West Station Lofts

Addendum #TTF-1

Date: July 18, 2017

Reference Drawing: TTF Drawings M-0 to M-9: Issued for Addendum #1 on July 17, 2017

Drawing M-8: Mechanical schematic & schedules

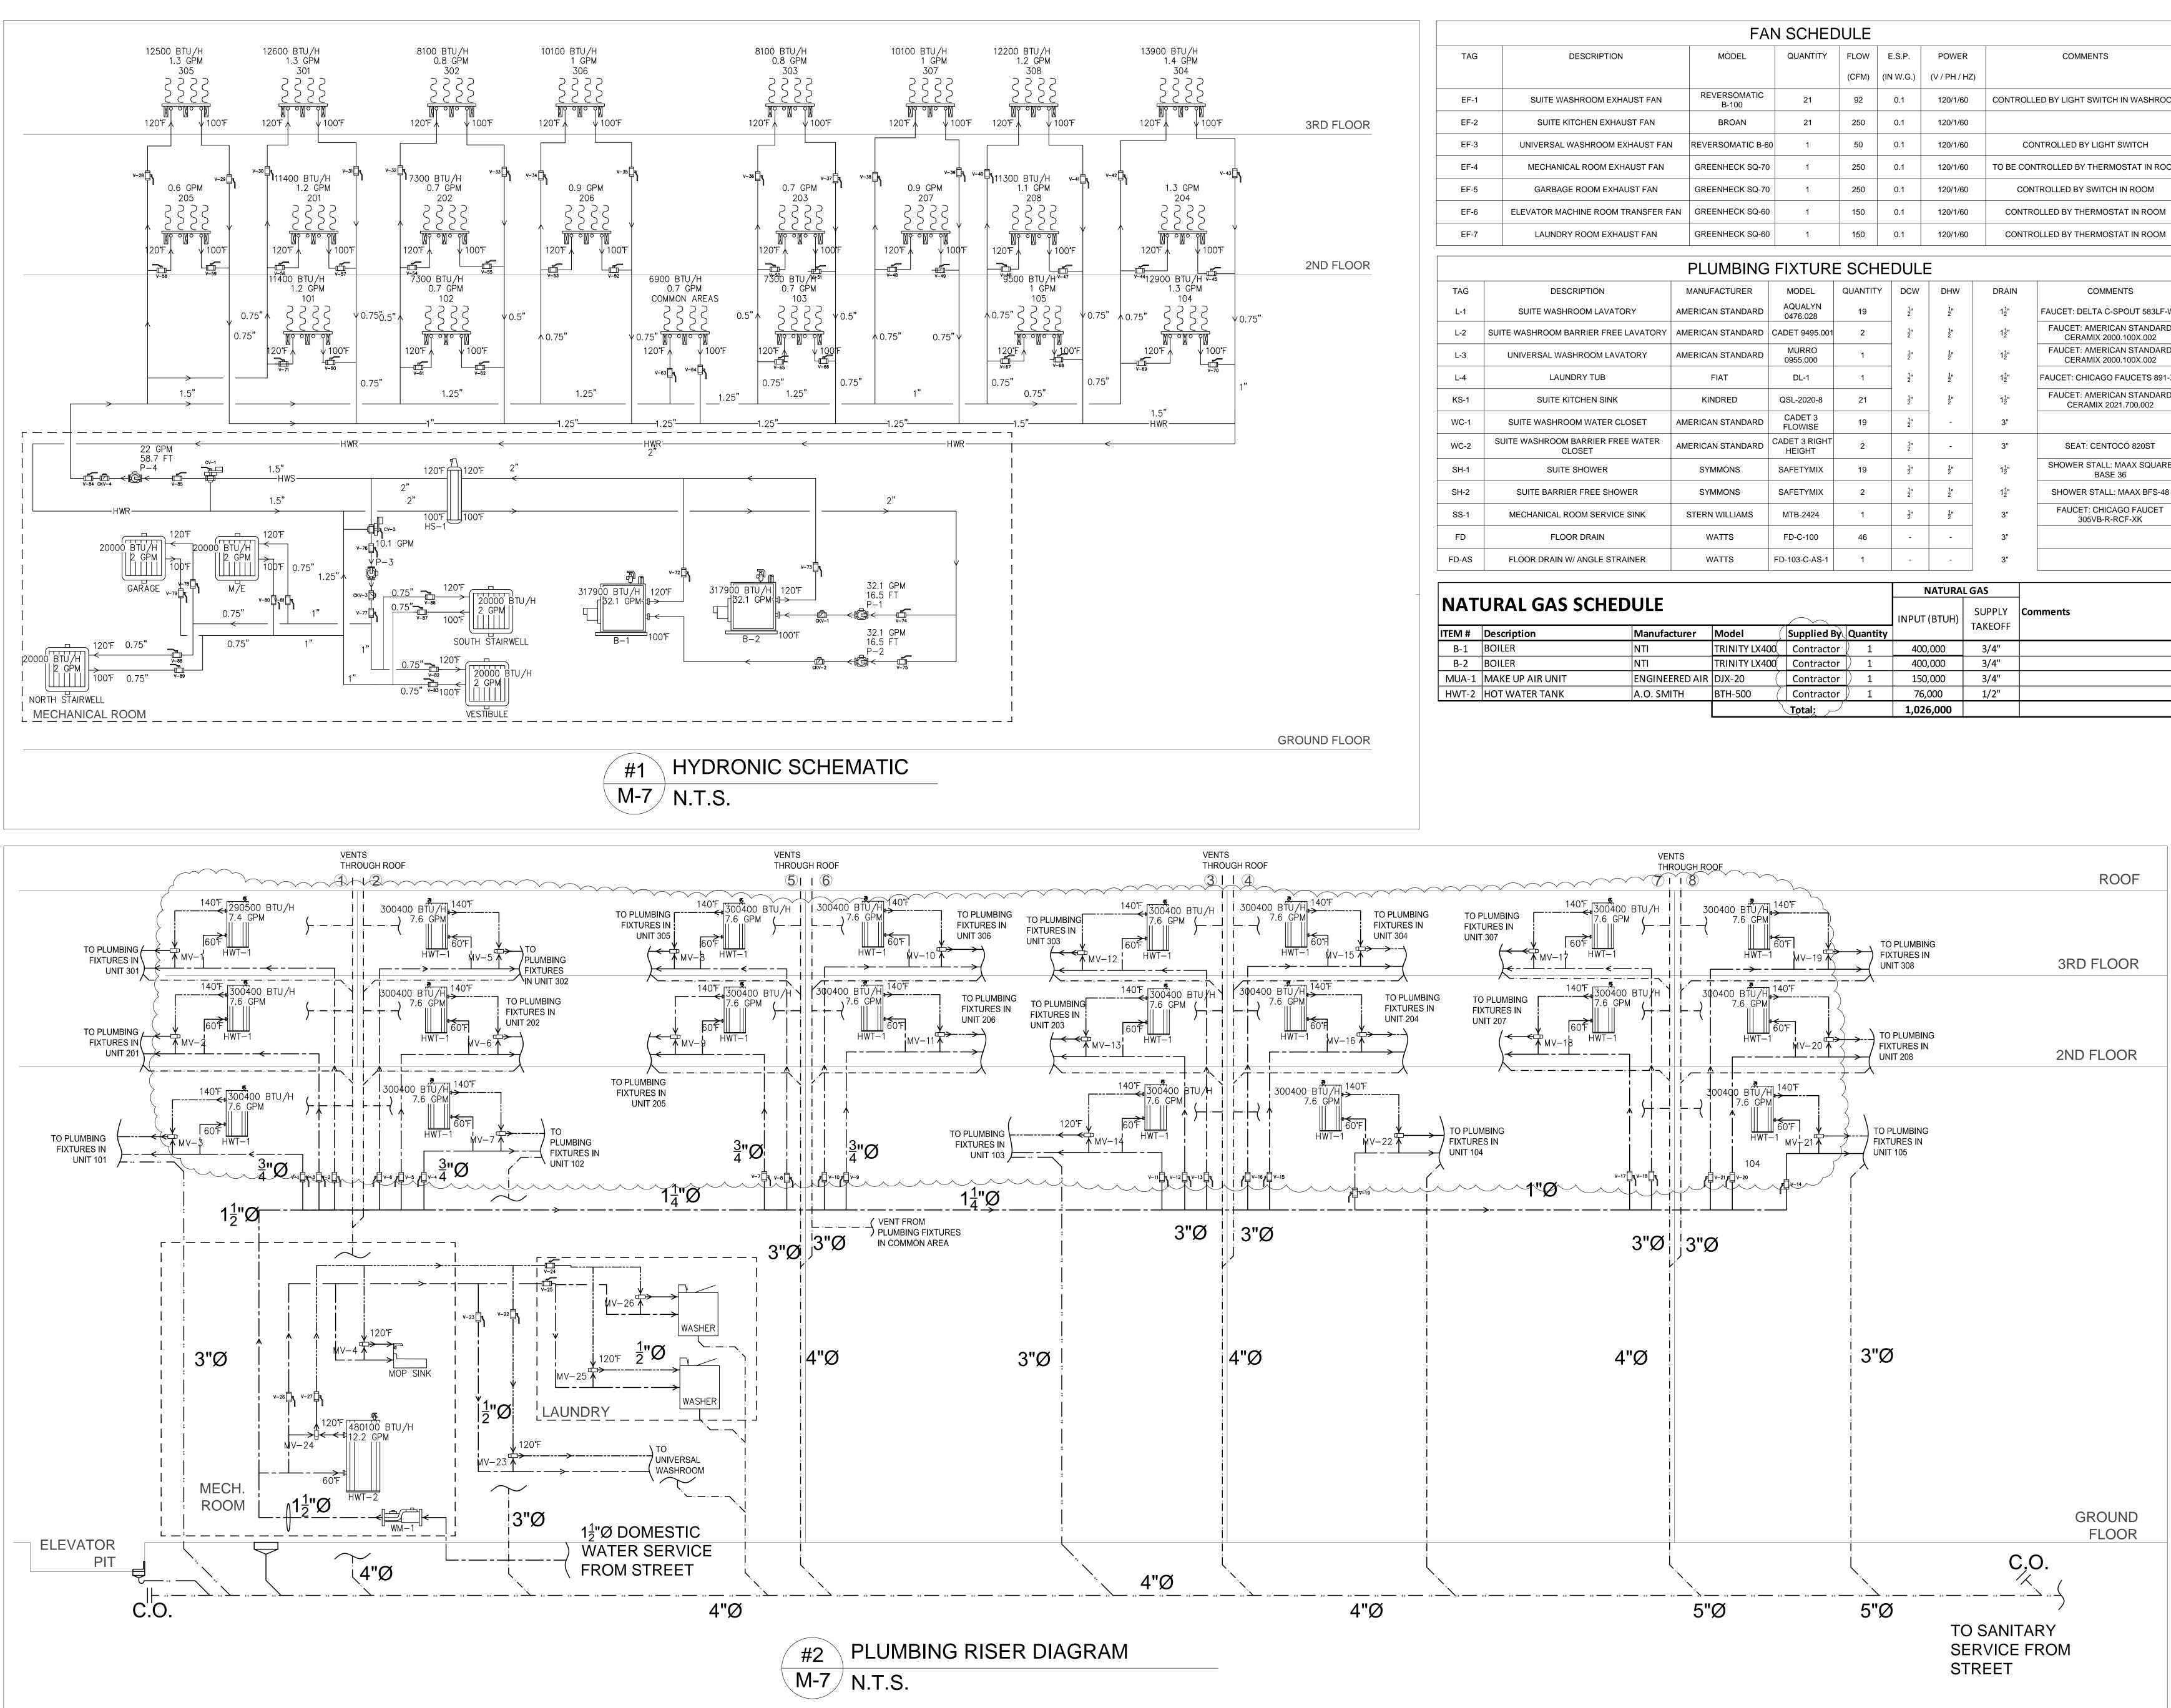
1. On drawing M-8 the natural gas schedule notes "supplied by others". This equipment is to be included in the contract. Please confirm.

2. On drawings M-8 all of the HWT's are labeled as 2 which is supposed to be gas fired but there is not natural gas running into each suite, clarification is required.

3. Drawing M-8 / Detail 2 (Plumbing Riser Diagram): shows HWT-2 as being 480,100 BTU/H in the mechanical room and 300,400 BTU/H in the individual suites. Drawing M-4 & M-6 indicate the suites are serviced with a HWT-1 (30 gallon electric). Please confirm which is correct?

Item A1-7 Plumbing riser diagram (Detail #2) has been updated.

Item A1-8 Natural gas schedule has been updated.

TTF Answer: Yes natural gas equipment are included in the contract. Refer to attached drawings.

TTF Answer: HWT-2 in mechanical room is natural gas fired and HWT-1 in each suite is electric.

TTF Answer: It should be electric 30gal HWT-1 in each suite as shown on M-4 & M-6. Plumbing riser diagram on Drawing M-8 has been updated. Refer to attached drawings.
